ADDENDUM NO. 03

TO: PLANS AND SPECIFICATIONS FOR STATE OF MISSOURI

Replace Fire Alarm System, Infrastructure
Farmington Correctional Center
PROJECT NO.: C2503-01

FA119

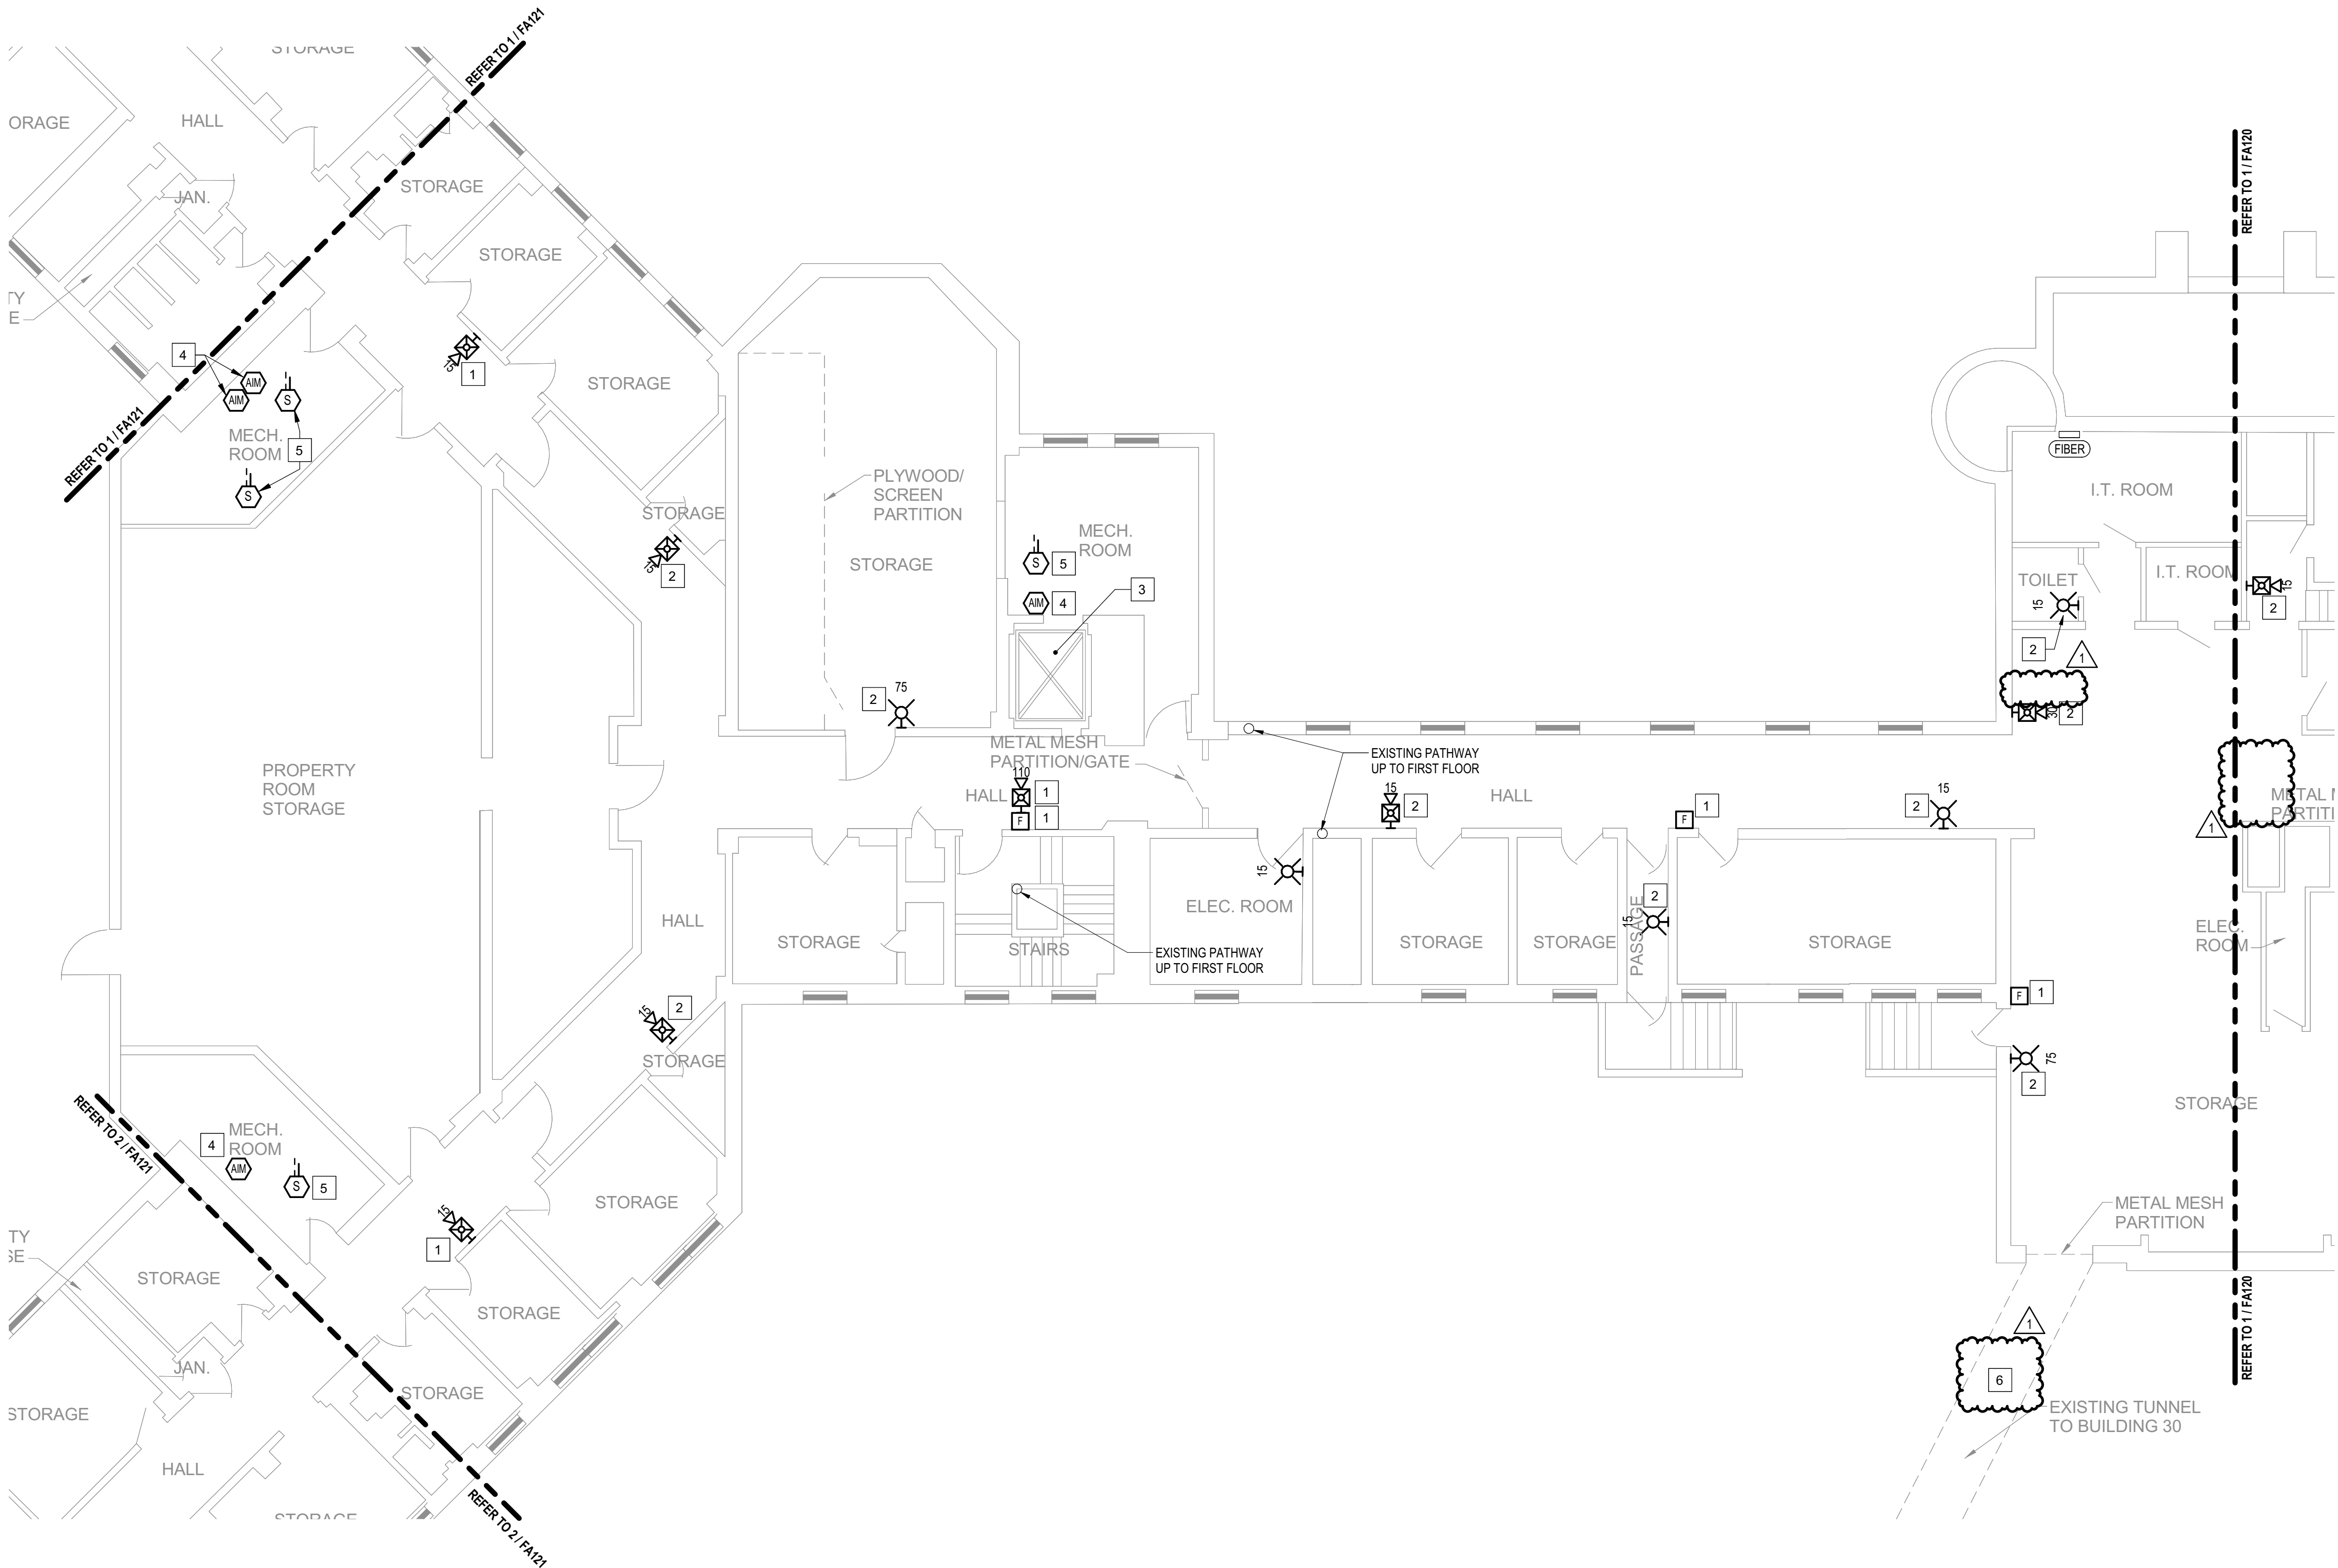
- a. GENERAL SHEET NOTE #2 REMOVED
23. FA119 - BUILDING 10 - BASEMENT - CENTRAL WEST - FIRE ALARM
- a. GENERAL SHEET NOTE #2 REMOVED
 - b. SHEET KEYNOTE #6 ADDED

- c. OLD EXISTING FIBER CABINET REMOVED FROM PLAN TO AVOID CONFUSION WITH NEW FIBER CABINETS.
24. FA120 – BUILDING 10 - BASEMENT - CENTRAL EAST - FIRE ALARM

FA120

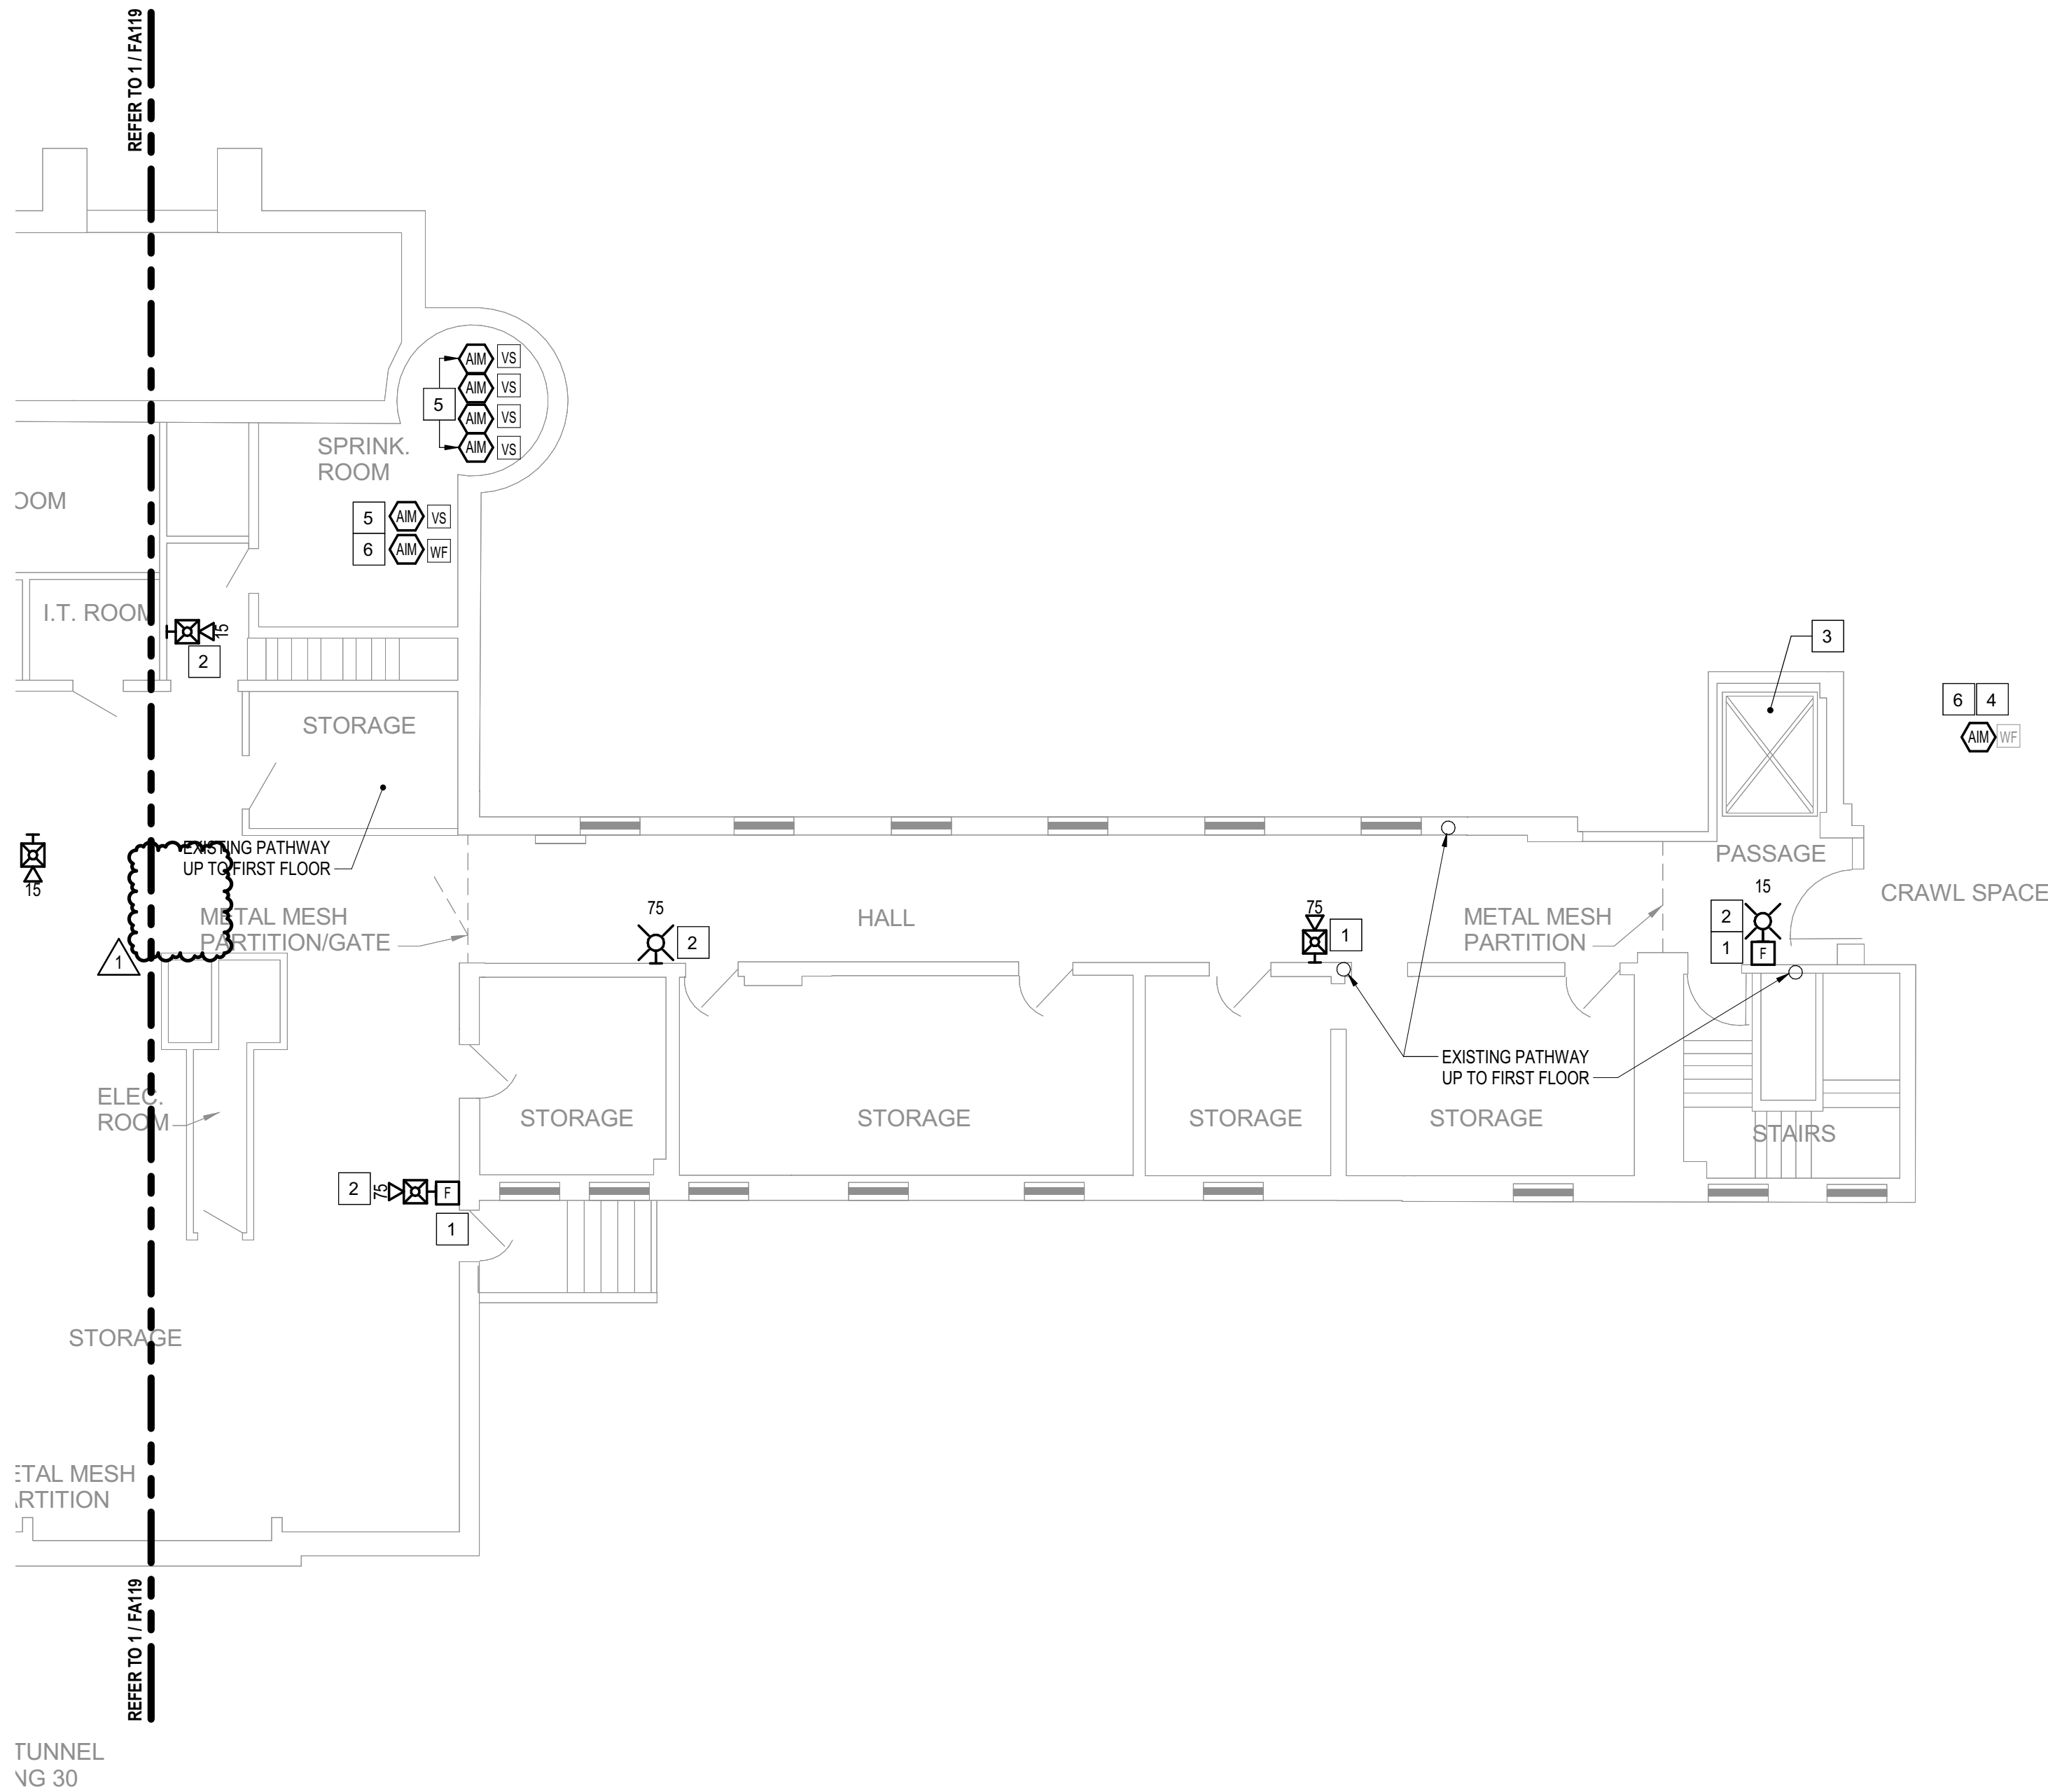
- a. GENERAL SHEET NOTE #2 REMOVED
 - b. OLD EXISTING FIBER CABINET REMOVED FROM PLAN TO AVOID CONFUSION WITH NEW FIBER CABINETS.
25. FA121 - BUILDING 10 - BASEMENT - NW & SW WINGS - FIRE ALARM

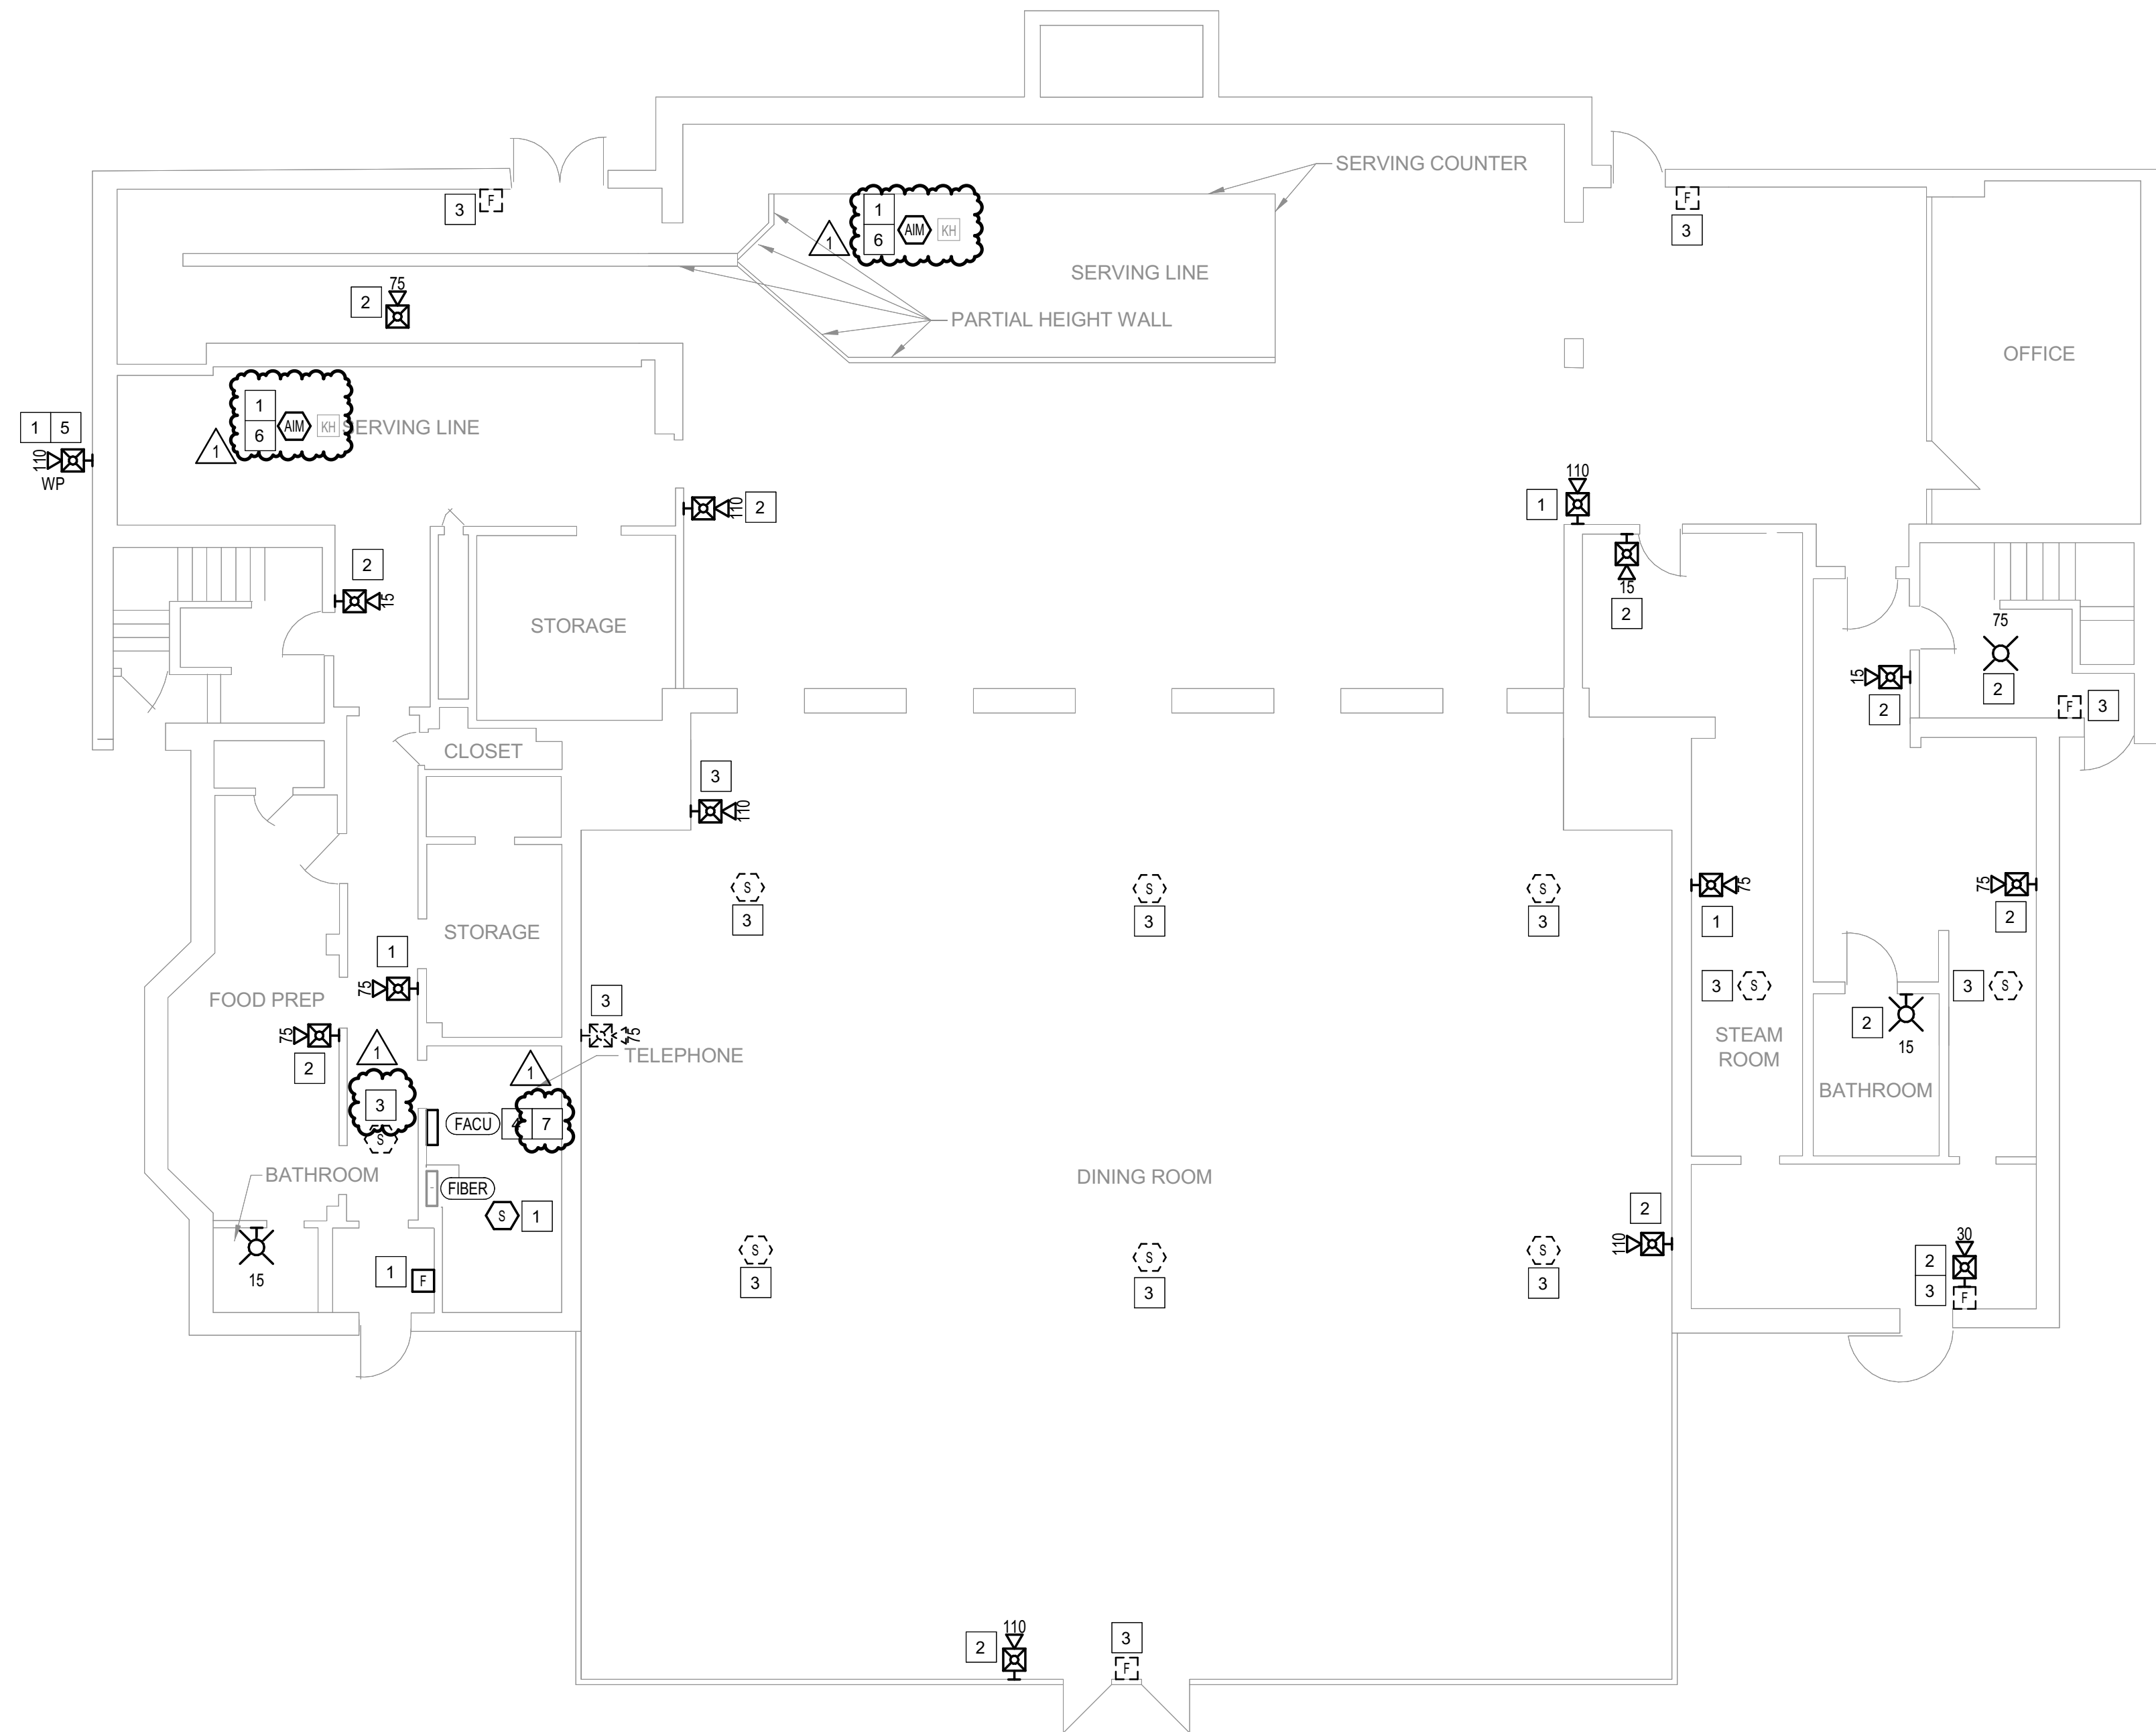
44. FA140 – BUILDING 17 - BASEMENT & LEVEL 1 - FIRE ALARM
- a. GENERAL SHEET NOTE #2 REMOVED
 - b. SHEET KEYNOTE #6 ADDED
 - c. SHEET KEYNOTE #7 ADDED
 - d. SHEET KEYNOTE #4 MODIFIED

- e. KITCHEN HOOD SUPPRESSION MONITORING DEVICES SHIFTED ON PLAN TO BE MORE ACCURATE.
 - f. KEYNOTE ANNOTATION ON SMOKE DETECTOR IN PLAN WEST CORRIDOR MODIFIED FROM 2 TO 3.
